**SPECIAL DEVELOPMENT REVIEW
COMMITTEE MEETING**

**TOWN OF BAY HARBOR ISLANDS
COMMUNITY DEVELOPMENT
MEMORANDUM**

Subject: Site Development Plan Application – #3 DRC Review
Proposed New Multiple-Family Development (33 DU)
Former Projects – 35 DU Project From 2018 Expired (MMPA #1065)
26 DU Project From 2020 Expired (MMPA #1098)
9919-9927-9955 East Bay Harbor Drive
Bay Harbor Islands Acct. No. SPR22-000021
MMPA Acct. No. 01-0702-1140

Date	08-25-2022	Sheet No. A2.00
Scale		
Project	2227

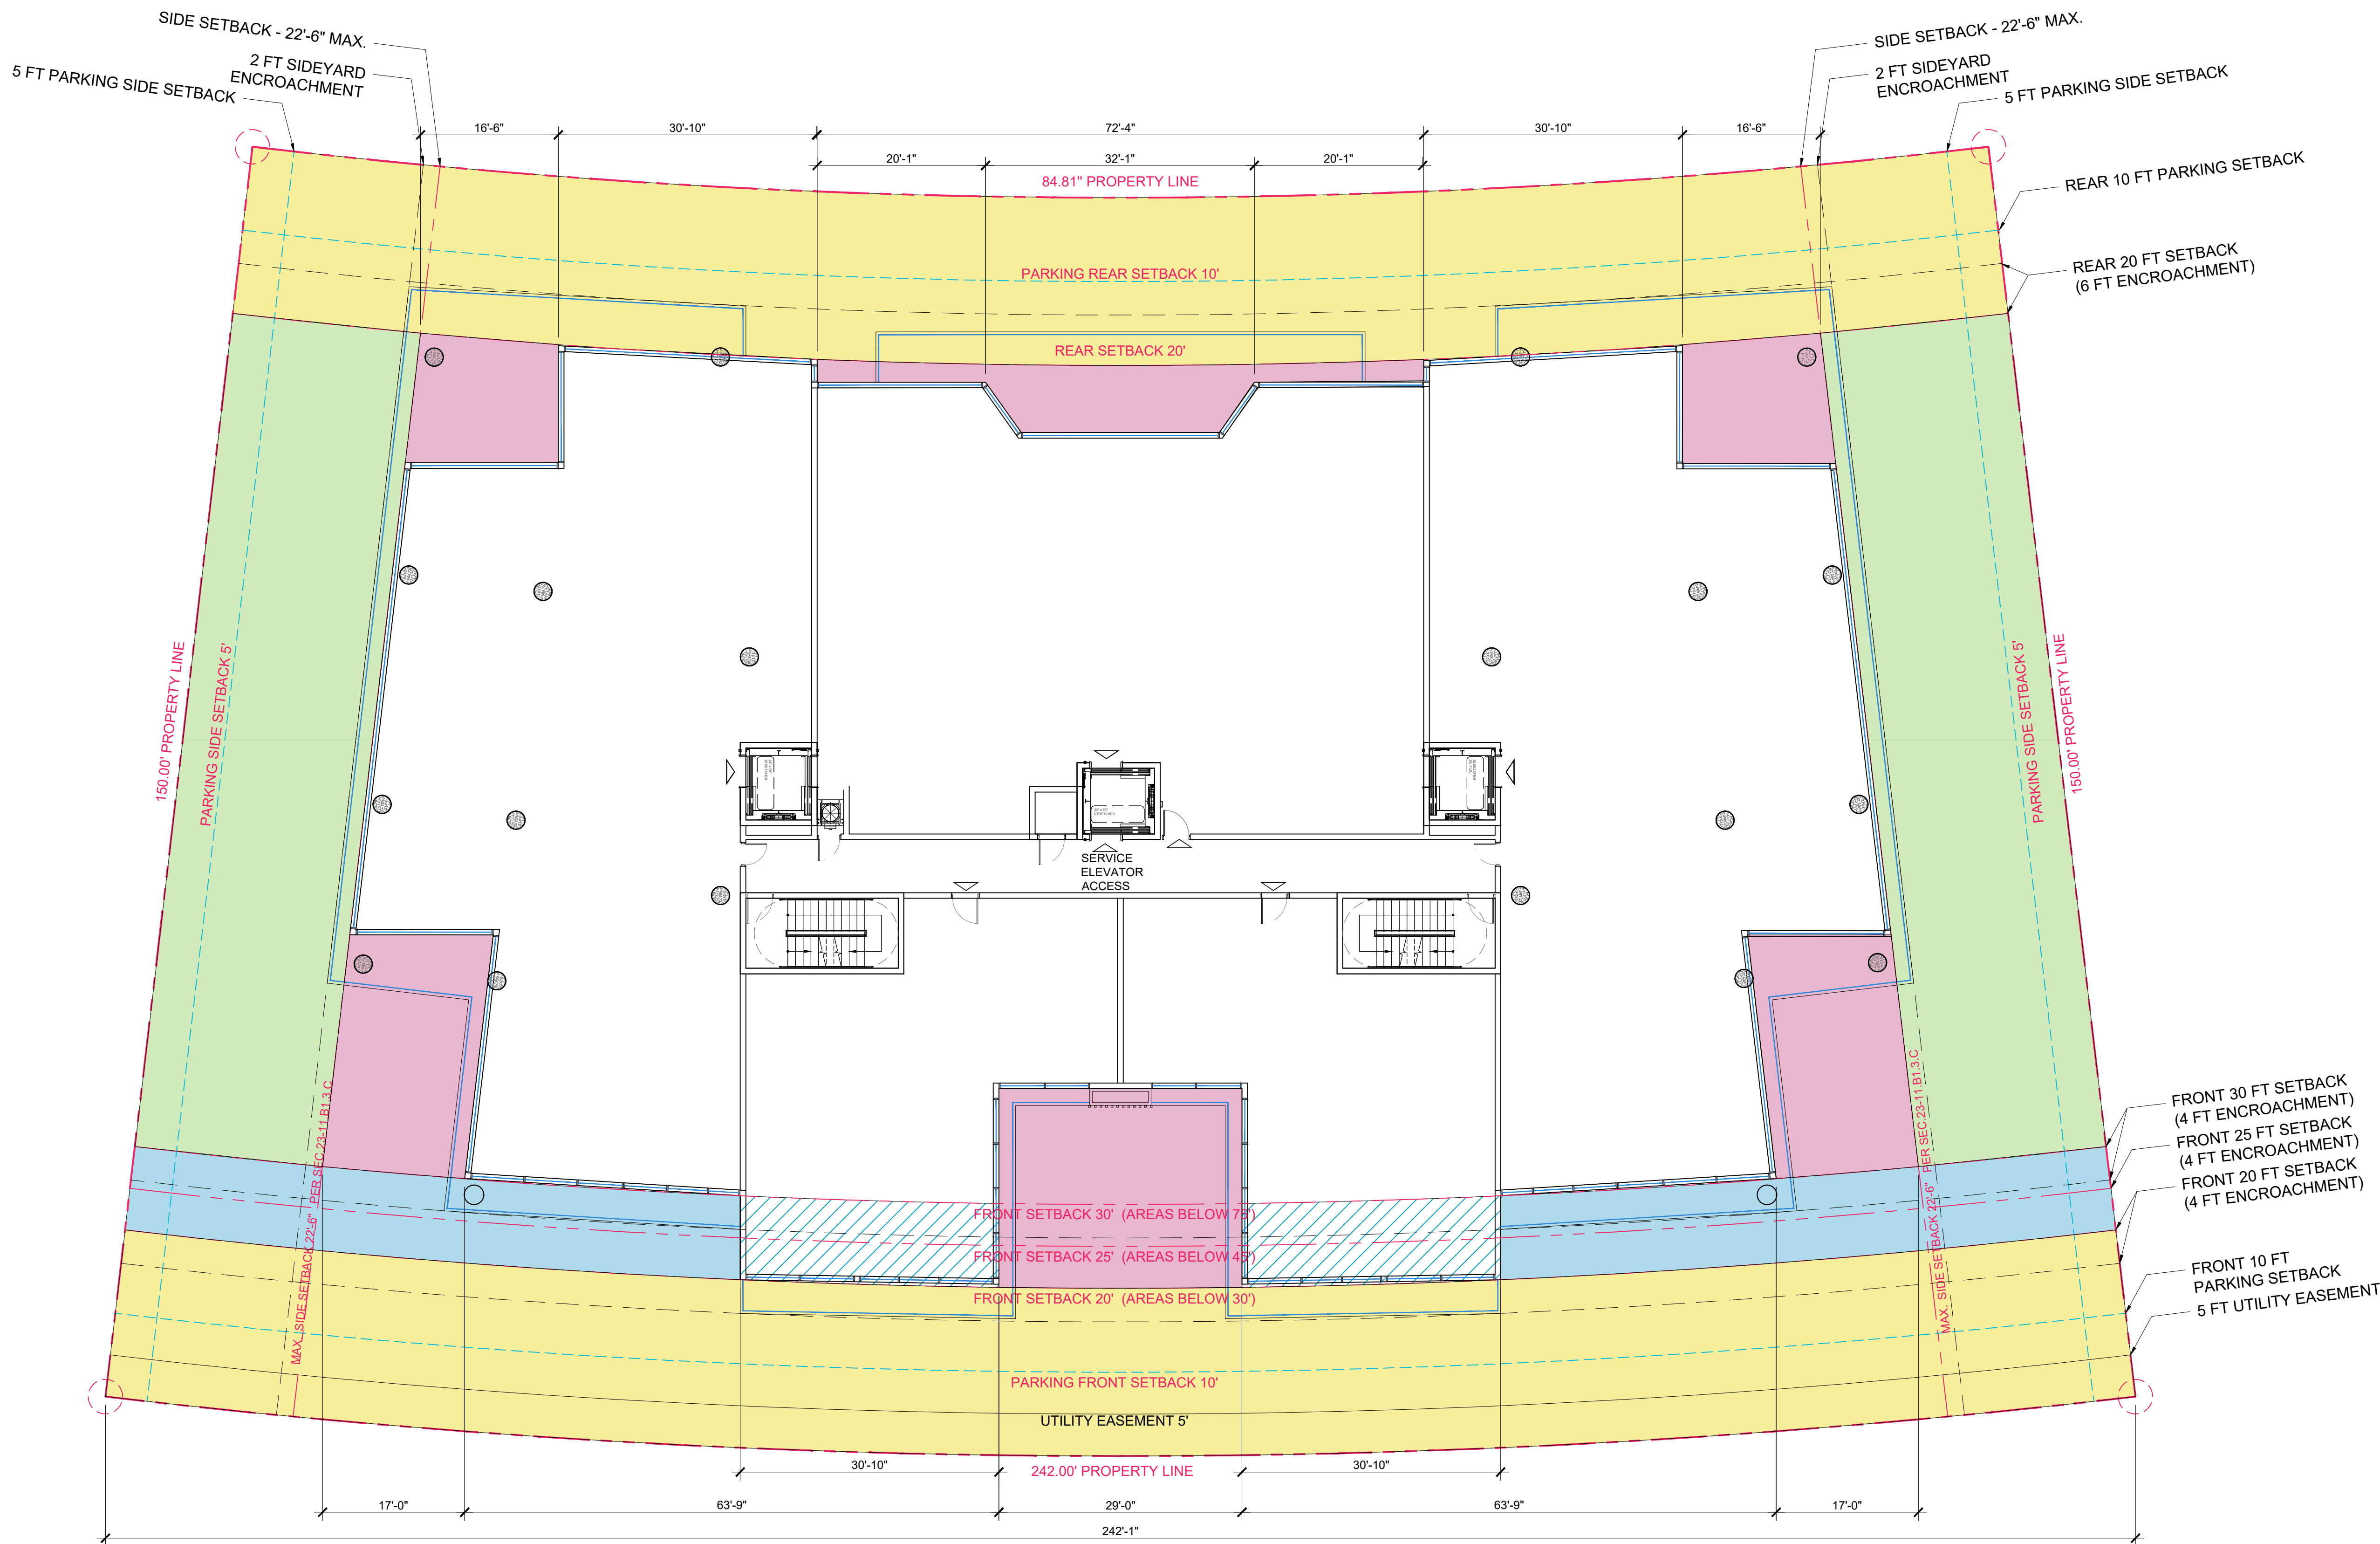
1. **Previous DRC Comment #4** - On Sheets A2.00 / A3.00 / Others some structural columns along the rear (waterfront) frontage still show encroaching into the minimum rear 20' building setback. Remove the columns / all structures out of the minimum setbacks.

All structural columns along the rear frontage have been removed from the setback. Please refer to revised site and floor plans (See Sheet A200, A301-A308).

Roof Deck Landscape Plan

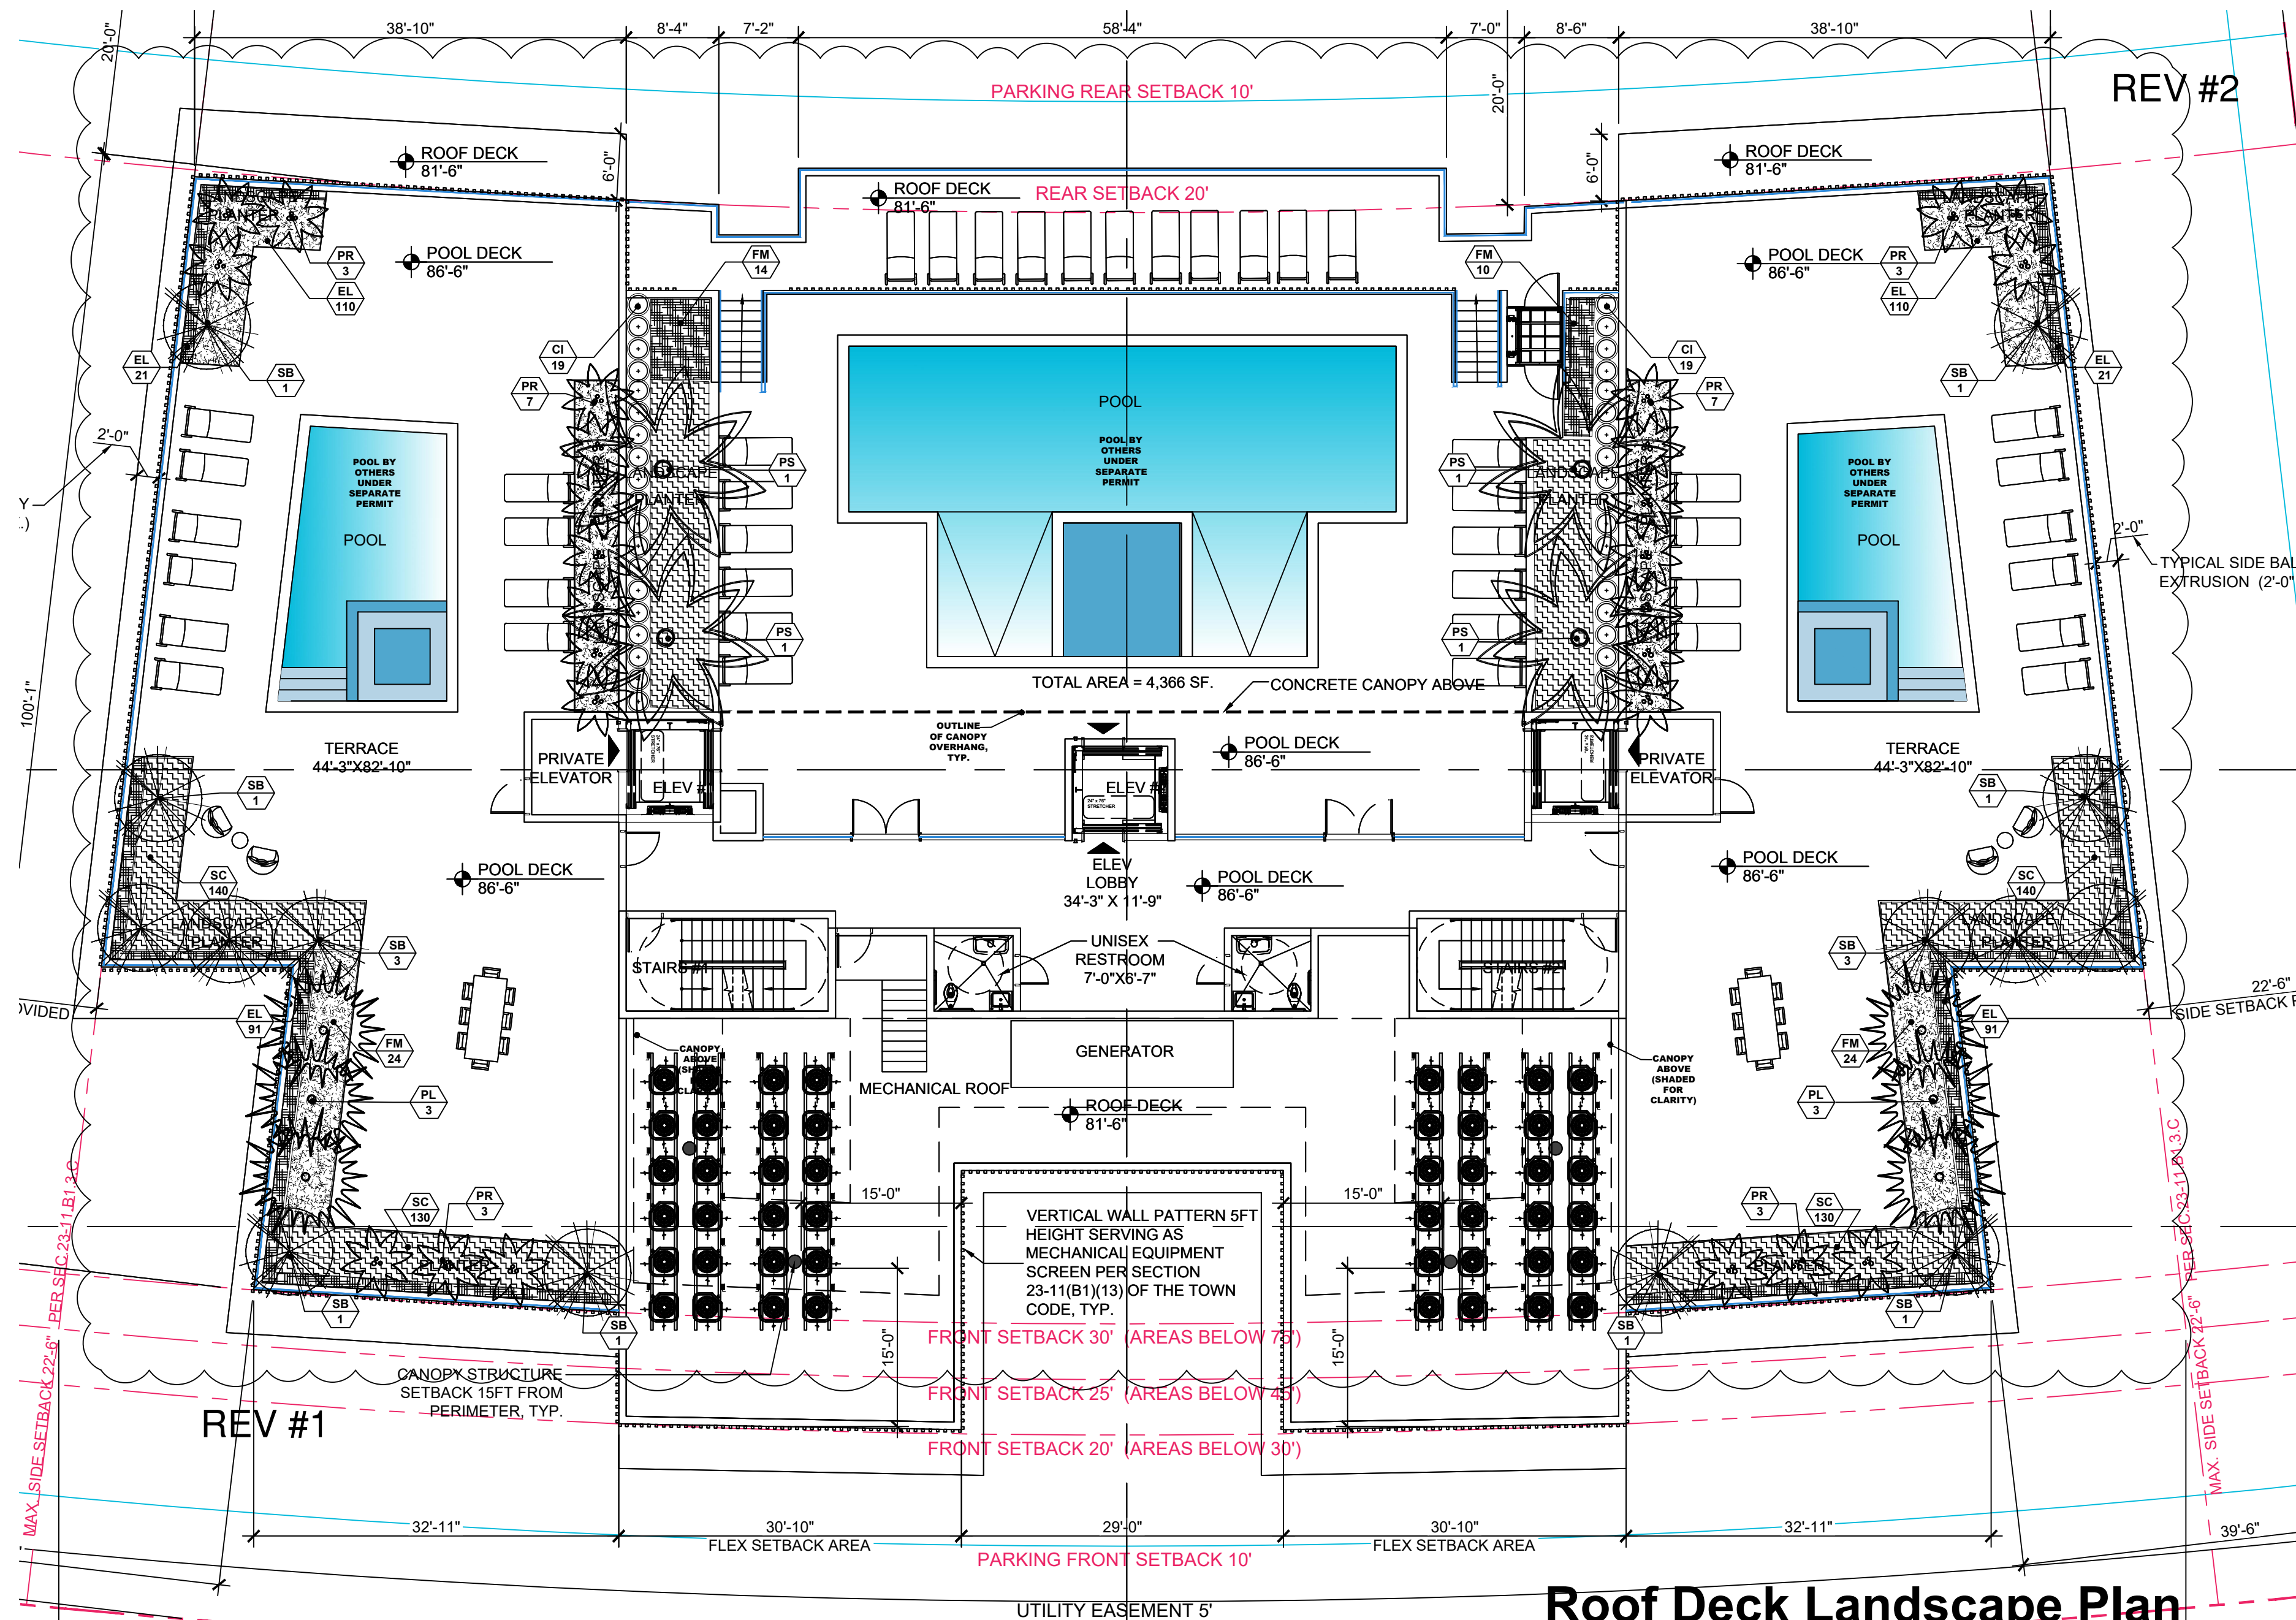
3. **Previous DRC Comment #10** - *Note: The revised plans are now internally inconsistent on Sheet L-1. The amount of project landscaped open space is much different on the Landscape Plan Sheet L-1. In the Landscape Requirement Legend shown at the upper left corner (25%) versus the lower right corner (20%). All other sheets were updated to 20%. Please revise Sheet L-1 to be internally consistent.

Sheet L-1 has been revised and internally consistent with architectural plans.
